RFI 137

Project: COOLEY LABORATORY RENOVATION
Job: 3146 COOLEY LAB, PPA# 10-0023
Customer: STOFMT MSU BOZEMAN
Issued To: CONSTRUCTION MANAGEMENT SERV.
P.O. BOX 7274
BOZEMAN, MT 59715

Item Fume/Hood Supply Duct Height Type: Mech/Lab
Reference: M2.0.2 Spec. Section:11605/15841
Attachments: None

04		LAB			
Qty.	Bldg.	Floor #	Room #	Arch. Ref.	
CP.01	01	01	B 010	QL1.0

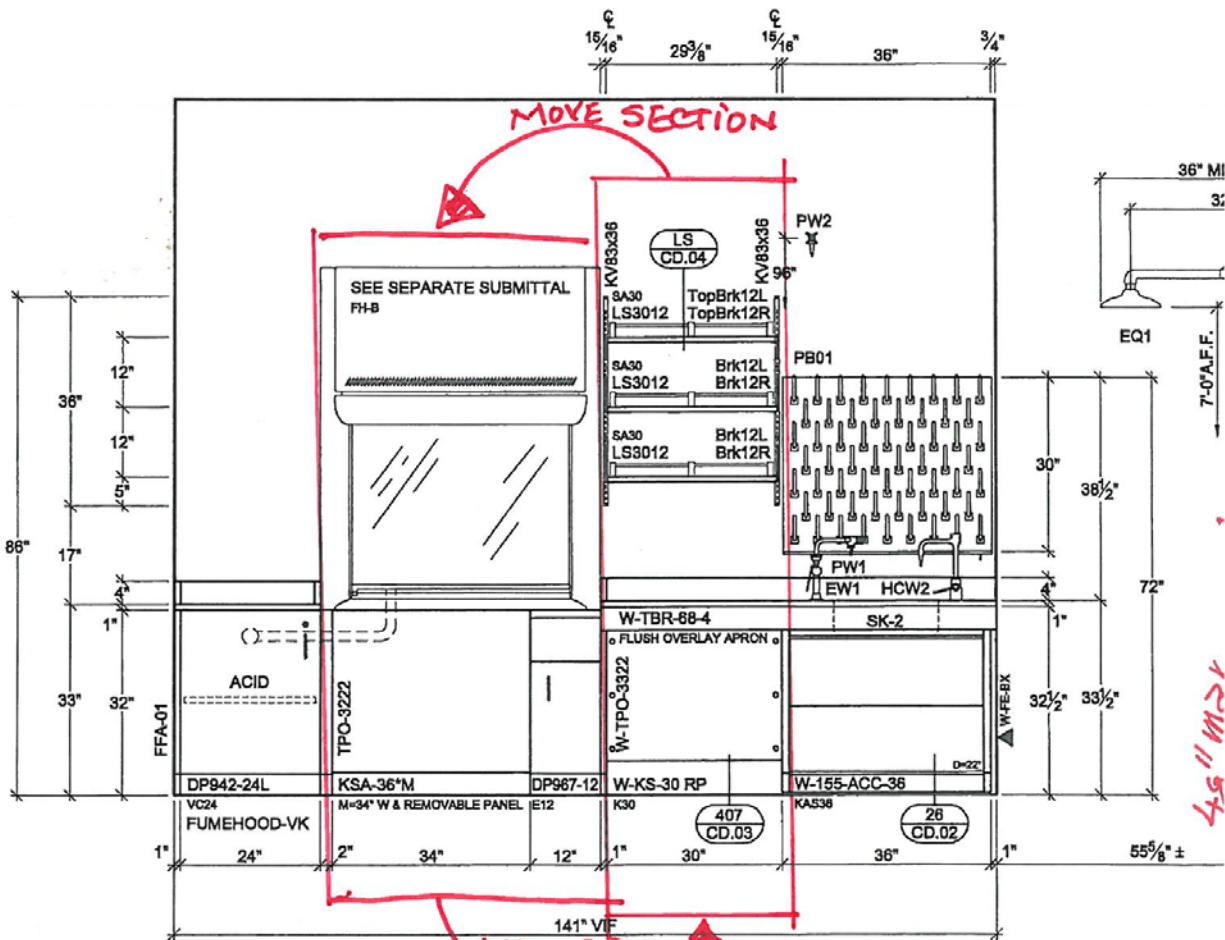
QUESTION:
In the Basement Room 012 the 30X18 supply duct will not allow the Fume Hood to be installed in that location. The obvious option would be to move the fume hood to the north 36".
Please Advise.

Move the fumehood to the north 31" . Adjust Base Casework and epoxy tops accordingly.

See Attached sketch.

ADA Note
 TOPS @ 34", PLEASE NOTE THAT
 34" IS "MAX" FOR ADA.
